CITY OF CAMBRIDGE
BUILDING DIVISION

WILLOW 3E (GR)
ELEVATION 1, 2 & 3

TITLE SHEET
BARLASSINA CONSTRUCTION
CITY OF CAMBRIDGE

MODEL:	
	WILLOW 3E	
	SCALE:	
	3/16" = 1'-0"	
	PROJ. No.	DWG. No.
	21-35	0

INVERTED STEEL ANGLE DETAIL

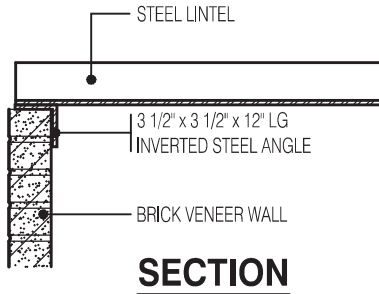
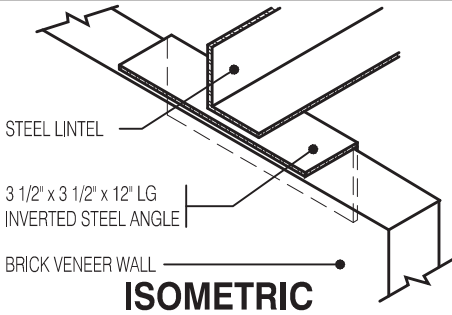
PROVIDE P.ENG APPROVED TRUSS & FLOOR DRAWINGS AND SPECIFICATIONS TO BUILDING INSPECTOR AT FRAMING INSPECTION

INSTALLATION OF FLUSH STEEL BEAMS SHALL CONFORM TO THE REQUIREMENTS OF 9.23.9.2.(3), (4) & (5)

P.ENG SOILS REPORT MAY BE REQ'D TO CONFIRM BEARING CAPACITY OF SOILS. SEE FIELD INSPECTOR

FINAL GRADING CERTIFICATE REQ'D BEFORE FINAL INSPECTION SIGN-OFF

ENERGY PERFORMANCE LABELS FOR ALL GLAZING PRODUCTS IDENTIFYING THE CERTIFIED VALUES SHALL REMAIN ON FOR REVIEW DURING CONSTRUCTION

WILLOW 3E
BASEMENT PLAN EL-3

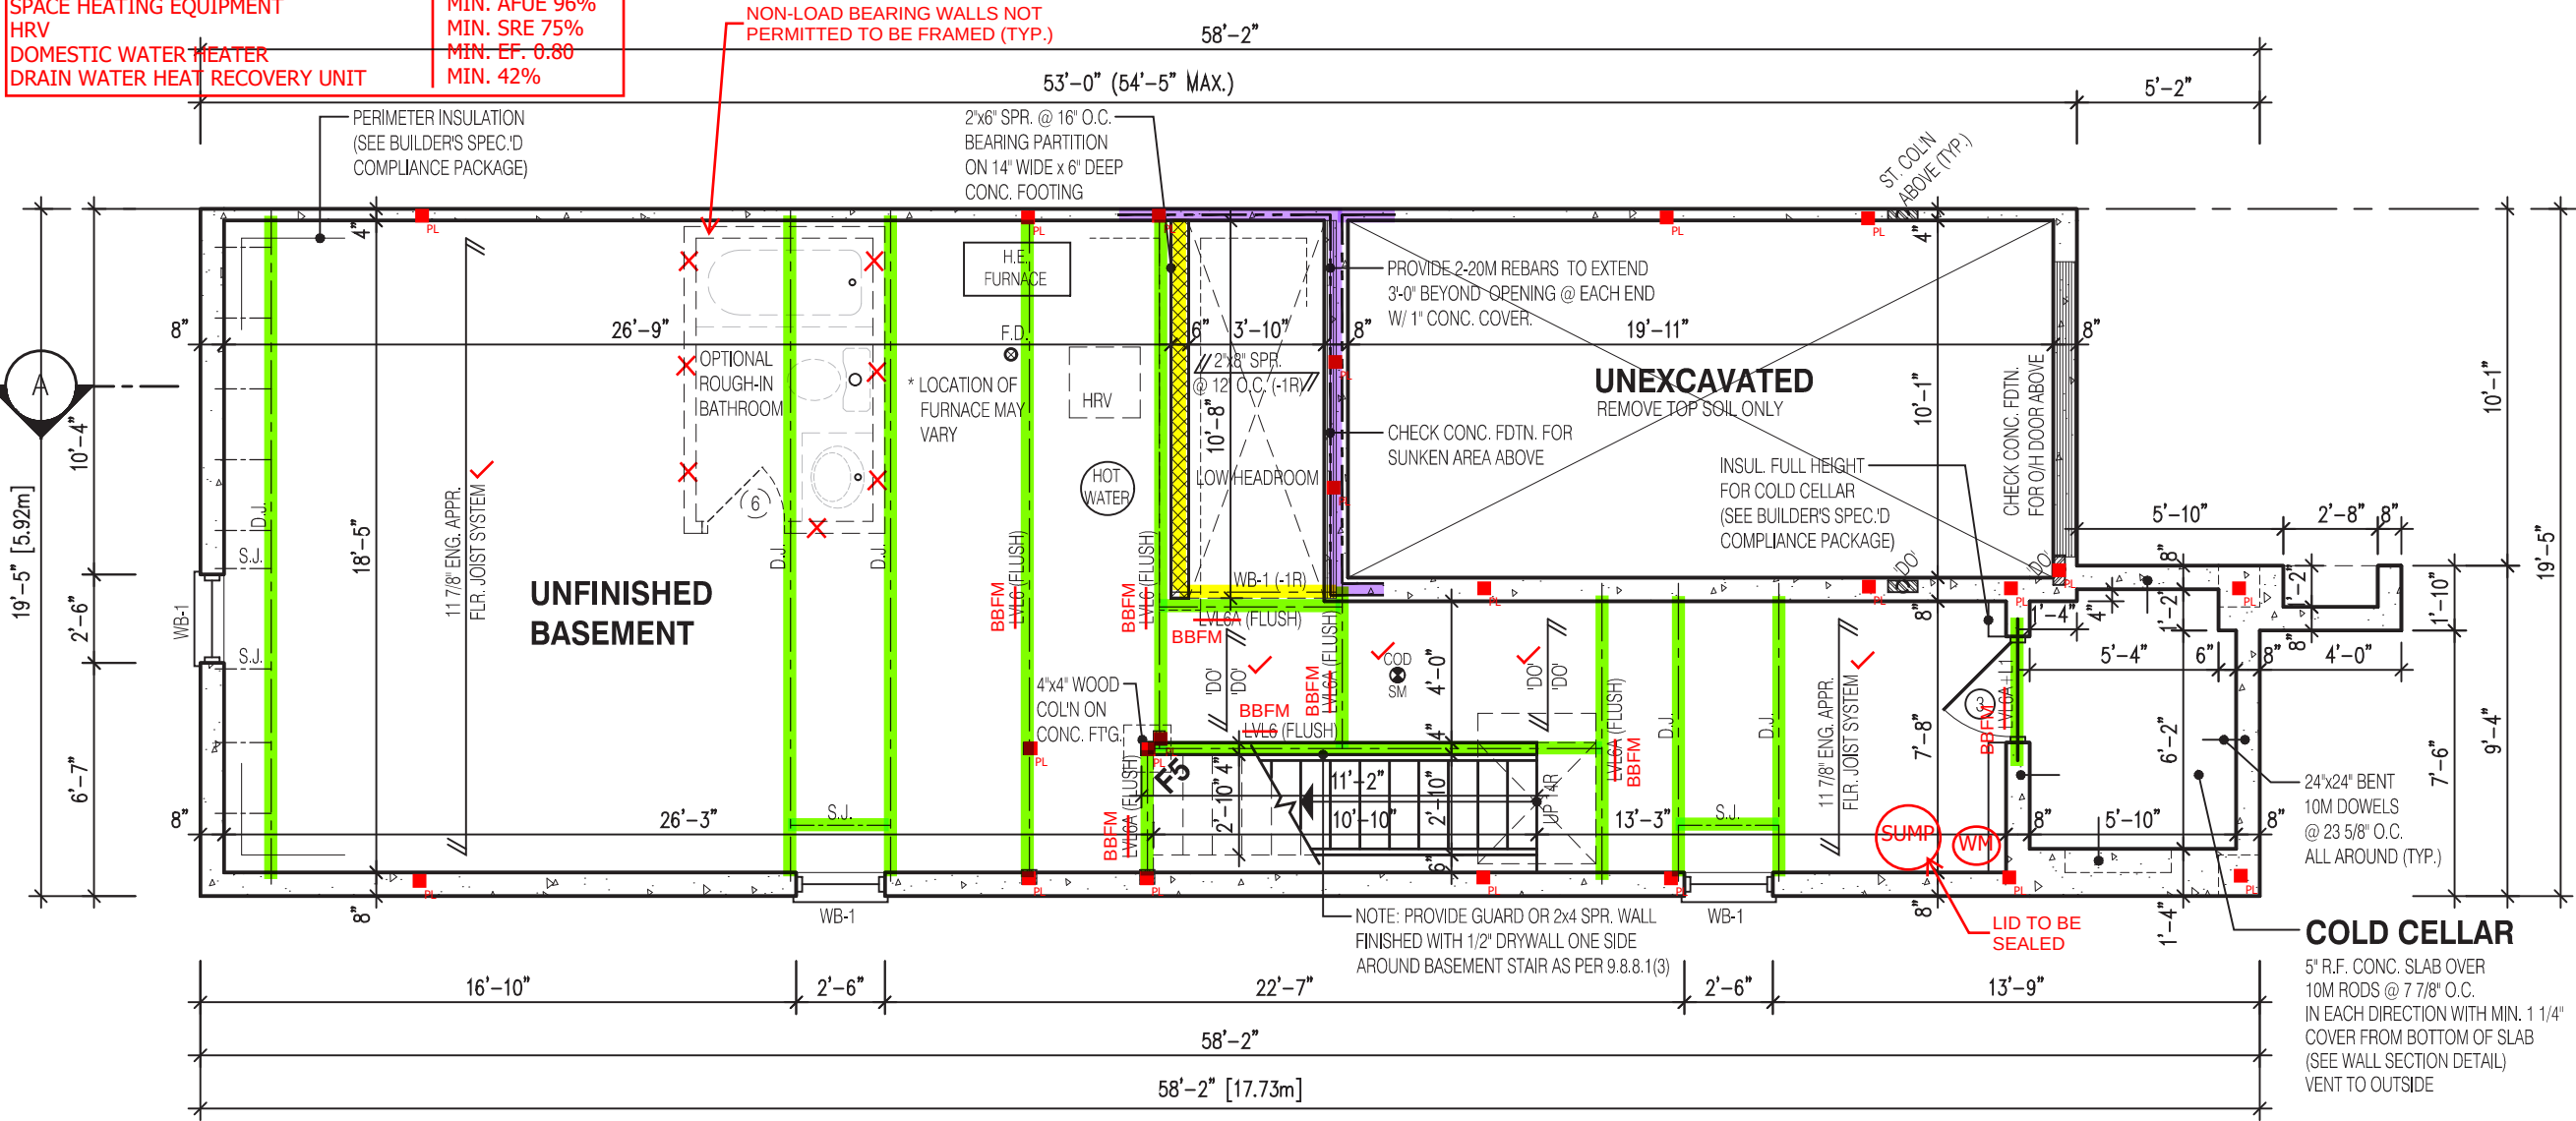
VERIFY WATER METER AND DWHR
UNIT LOCATION WITH INSPECTOR

SPRAY FOAM/RIGID INSULATION TO BE
PROTECTED AS PER 9.10.17.10.(1)

WATER METER TO BE INSTALLED WITHIN 2m
(6'-6") FROM THE POINT THE WATER SERVICE
PIPE MEETS THE BUILDING LINE

REQUIRED CONTINUOUS INSULATION
CANNOT BE INTERRUPTED BY FRAMING
MEMBERS SUCH AS STUDS

LEFT SIDE ELEVATION 3
UNPROTECTED OPENINGS

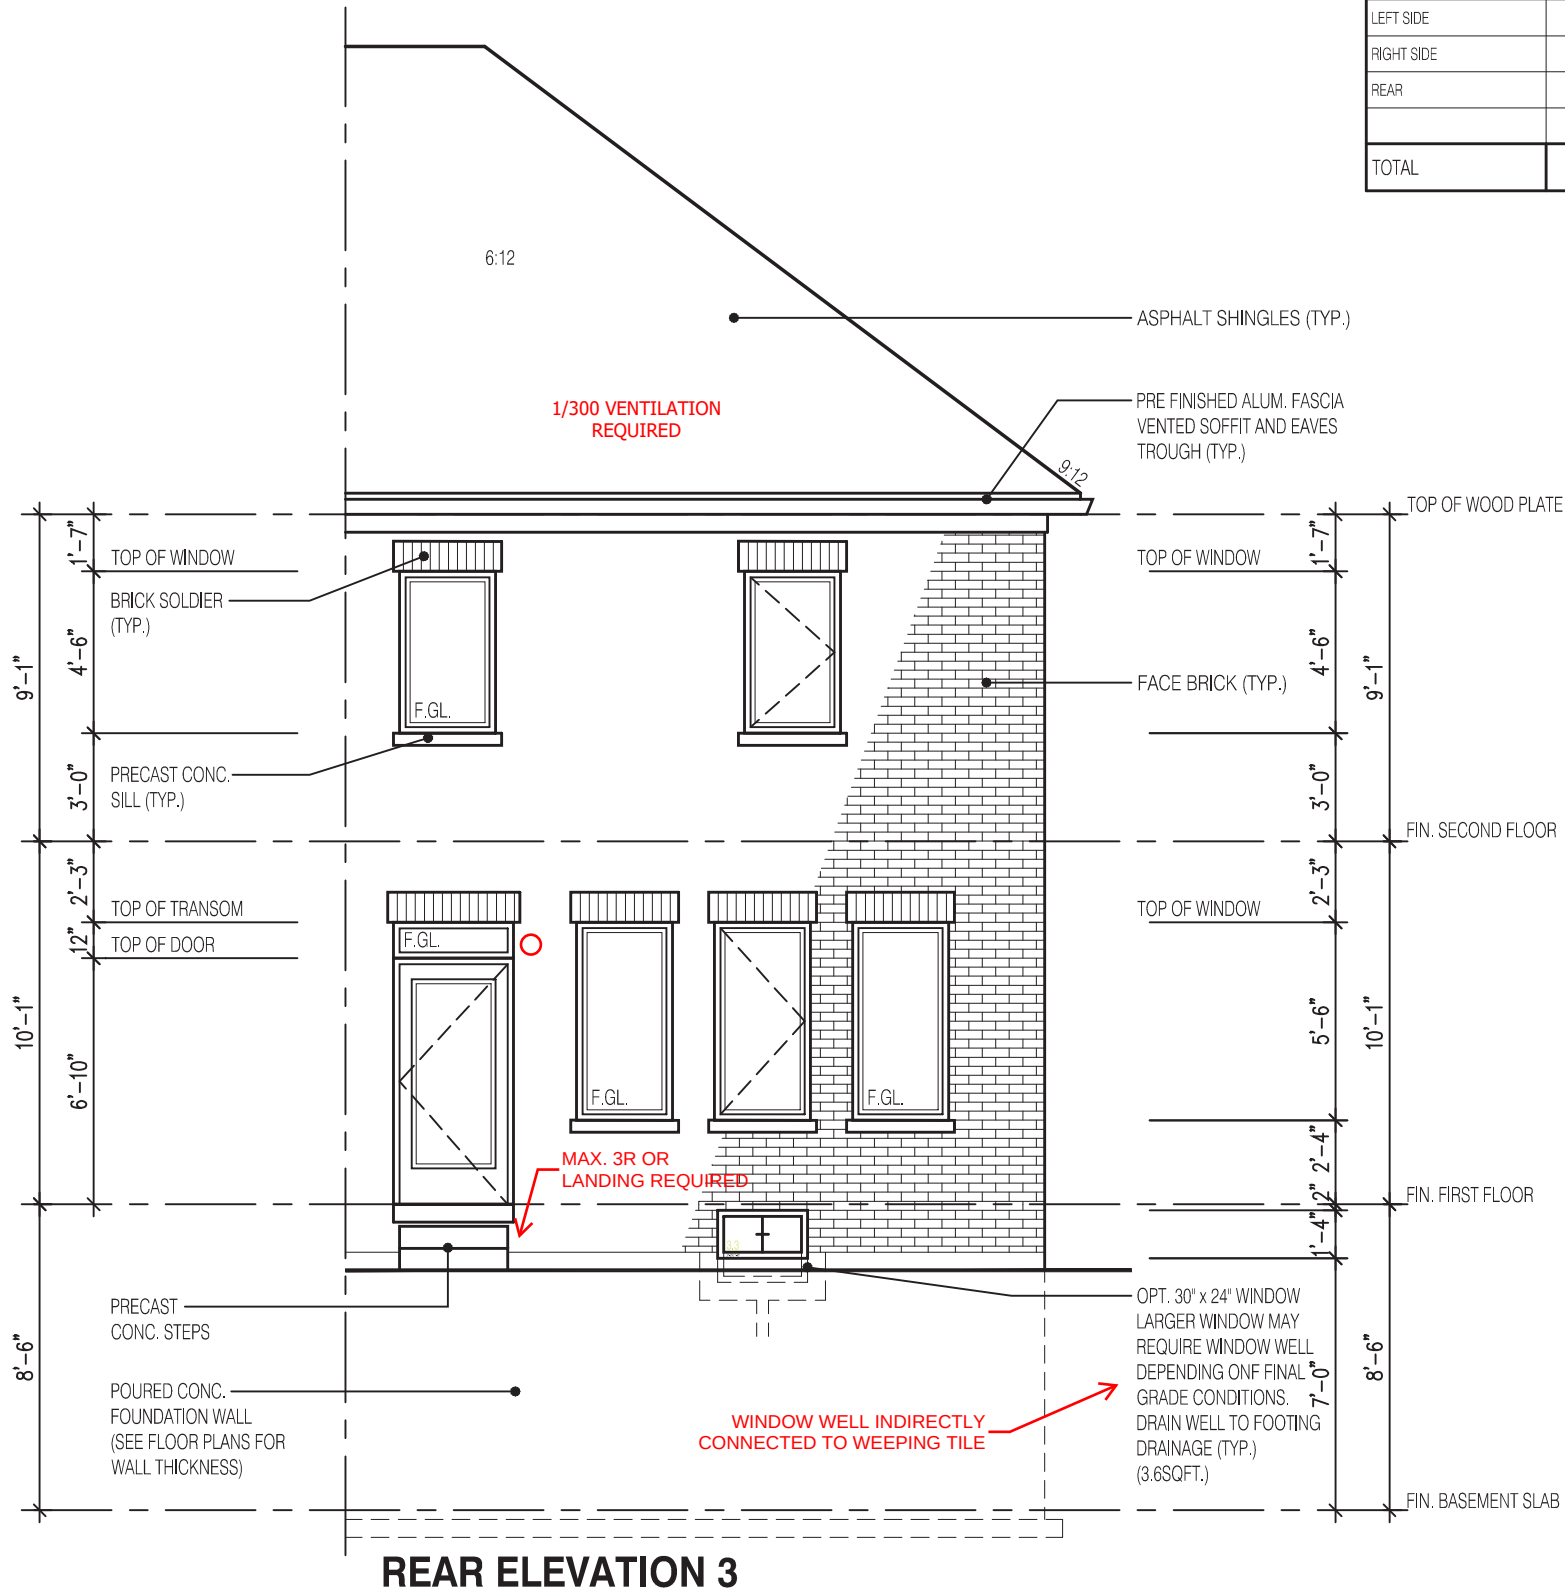
1161 ϕ
81.27 ϕ
~~71.60 ϕ~~
60.91 $\checkmark$

~~UNPROTECTED OPENINGS (WITH OPT. 30" x 24" WINDOWS)~~

~~WALL AREA
ALLOWABLE WINDOW AREA @ 7.0%(1.5m SIDEYARD)
ACTUAL WINDOW AREA~~

~~ENLARGED WINDOWS NOT
SHOWN ON THIS ELEVATION~~

~~1161 ϕ
81.27 ϕ
75.00 ϕ~~
